Work Order ID 90604

Item Name: Rear Locker Extender

From: Alisa Langille <alangille@solvecomposites.com>
Sent: Monday, November 12, 2012 11:25 AM
To: 'Eric Downing'; 'Jerry Reyell'
Cc: 'Isam El-Kassis'; psmith@dartaero.com; 'L Lacelle'
Subject: RE: PO17976 rear lockers

From: Eric Downing [<mailto:edowning@dartaero.com>]
Sent: Monday, November 12, 2012 11:00 AM
To: Jerry Reyell; 'Alisa Langille'
Cc: Isam El-Kassis; psmith@dartaero.com; 'L Lacelle'
Subject: PO17976 rear lockers

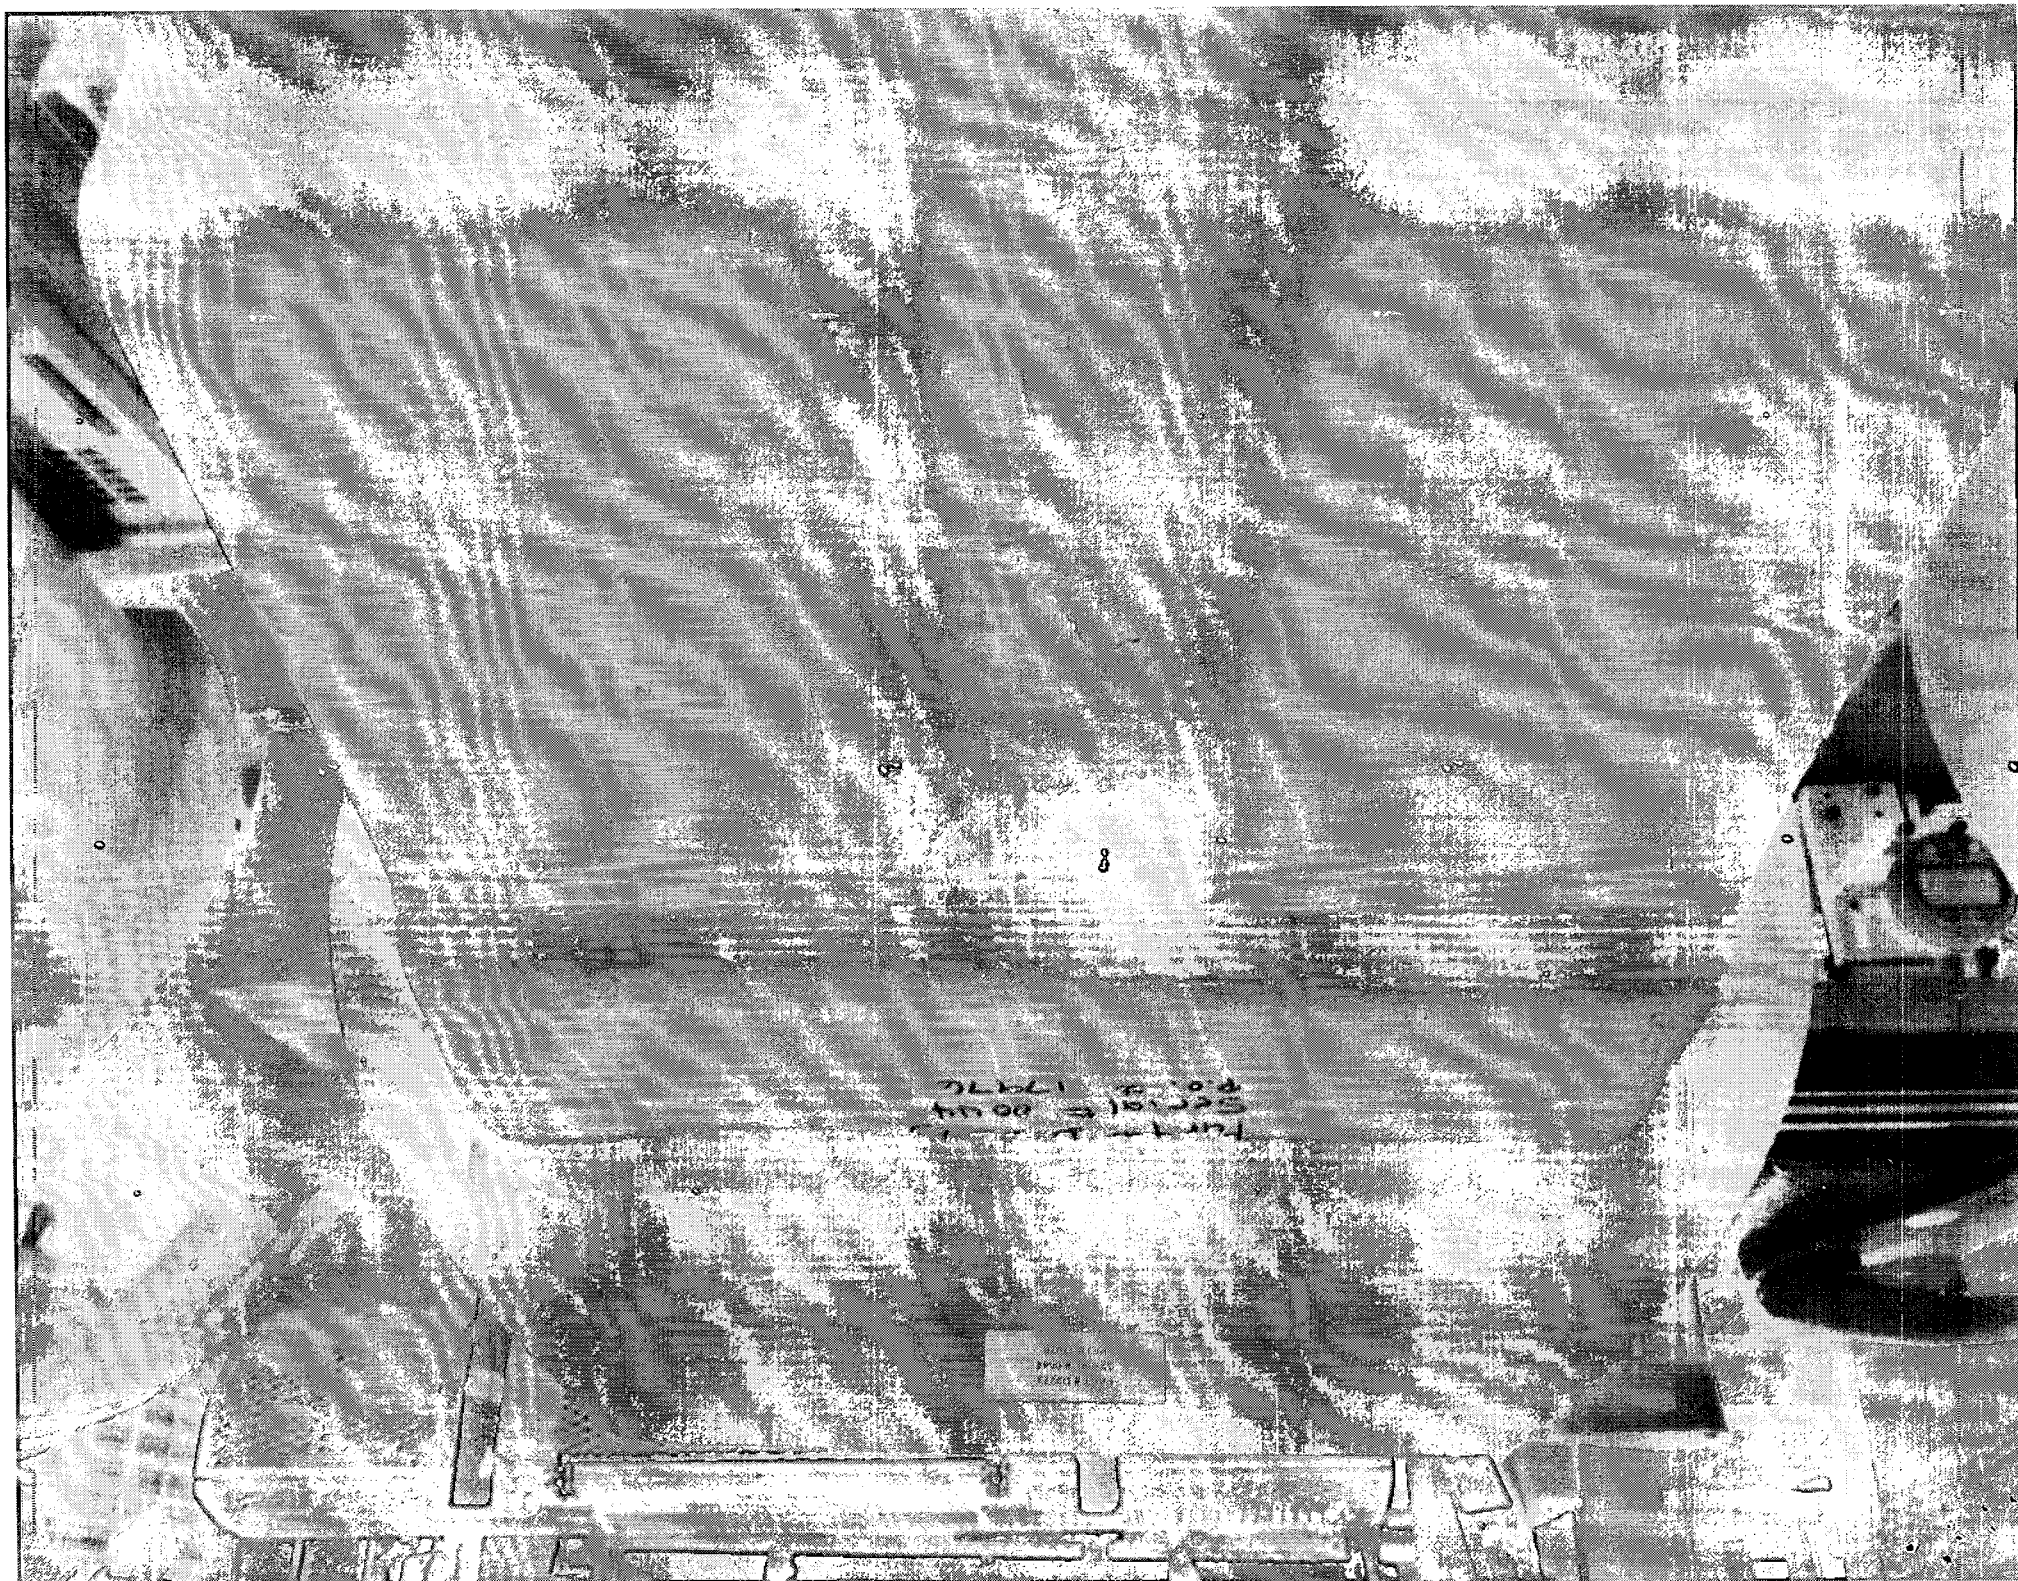
Hope all is good. I came in this morning and started to inspect the latest rear lockers that was received in here at Dart on the 1st of November and found the outside finish is way too rough and the primer is flacking off. I have attached pictures of the problems.

To me the primer flacking off would be the results that the rear lockers were not scuffed enough for the primer to correctly adhere to the rear lockers. Also the outside finish is way too rough to pass. I think again your team will have to sand/buff the outside before applying the primer will solve the issue of the roughness as well.

I am surprised that the lockers were not acceptable as I was informed by my team that they were the best we had sent. I will share the pictures with them and assure that this will not happen with any future delivery.

I think that the rework can be done here at Dart so there is no need to return the rear lockers but I hope that this little issue can be rectified at your end and if there are any questions please call and we can figure out the solution.
